APPENDIX 103

UNITIZATION PROCEDURES FOR BOXED AMMUNITION AND COMPONENTS ON 4-WAY ENTRY PALLETS

DETONATION SIMULATOR, PACKED 2,500 PER WOODEN BOX, UNITIZED 8 BOXES PER 35" X $45\frac{1}{2}$ " PALLET; APPROX BOX SIZE $24\frac{1}{4}$ " L X $17\frac{1}{2}$ " W X $15\frac{1}{16}$ " H

REVISION NO. 1, DATED SEPTEMBER 1985, CONSISTS OF:

PALLET UNIT

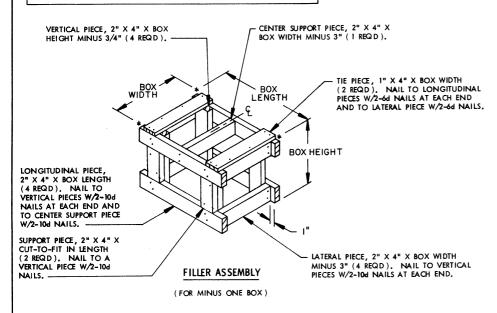
- 1. CHANGING BOX DIMENSIONS.
- 2. ADDING HAZARD CLASSIFICATION NOTE AND GENERAL NOTE "J".

- J. THE STYLE IA PALLET DELINEATED IN THE DETAIL AT LEFT NEED NOT HAVE CHAMFERS OR STRAP SLOTS AS SPECIFIED WITHIN MILITARY SPECIFICATION MIL-P-15011 WHEN USED FOR THE UNITIZATION OF THE ITEMS COVERED BY THIS APPENDIX. IF THE PALLET TO BE USED DOES NOT HAVE STRAP SLOTS, HOWEVER, THE LOAD STRAPS MUST BE PRE-POSITIONED ON THE PALLET DECK PRIOR TO PLACING THE BOXES ON THE PALLET.
